From: Boyum, Dan <Dan.Boyum@stantec.com>
Sent: Monday, September 28, 2020 1:21 PM
To: cityclerk@stacymn.org; Tanner Jones
Subject: RE: ROW Trees
Attachments: 311th 3W.JPG; 311th 2W.JPG

Subject: ROW Trees

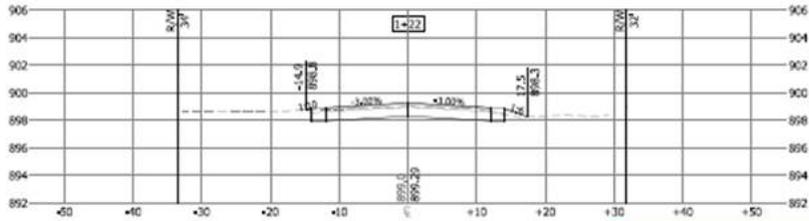
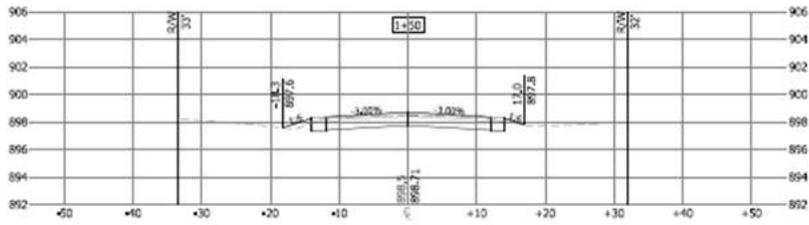
It look like the existing trees were evergreens from the first view below. The trees look further away than some of the trees on 312th. Also are two pictures showing the trees on the left side of the picture.

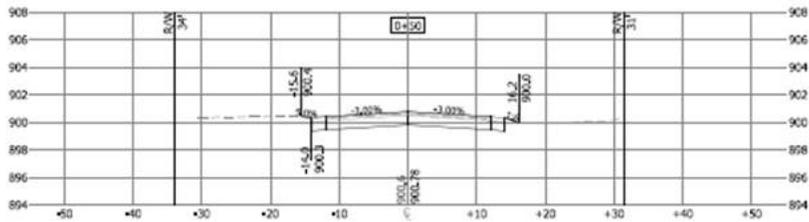
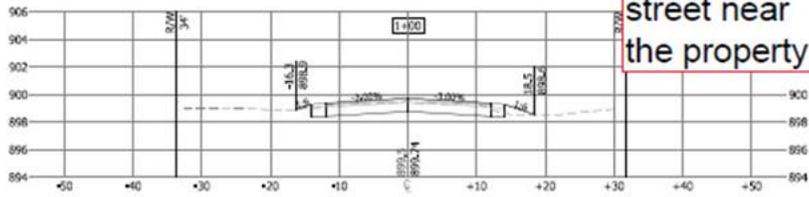
The second view are the cross-sections in this area. The cross-sections are showing more of a fill in this area than a cut. However I know how adjustments could have been made in the field related with ditch grading. We would have shots on the existing ditch elevation in this area from the original survey and could compare it to the new ditch. However I would defer to Tanner on what he recalls if one tree was taken down in the past. I can try to see what Jeremy has in his correspondence file too if this issue came up before.

This is the side of the street near the property.
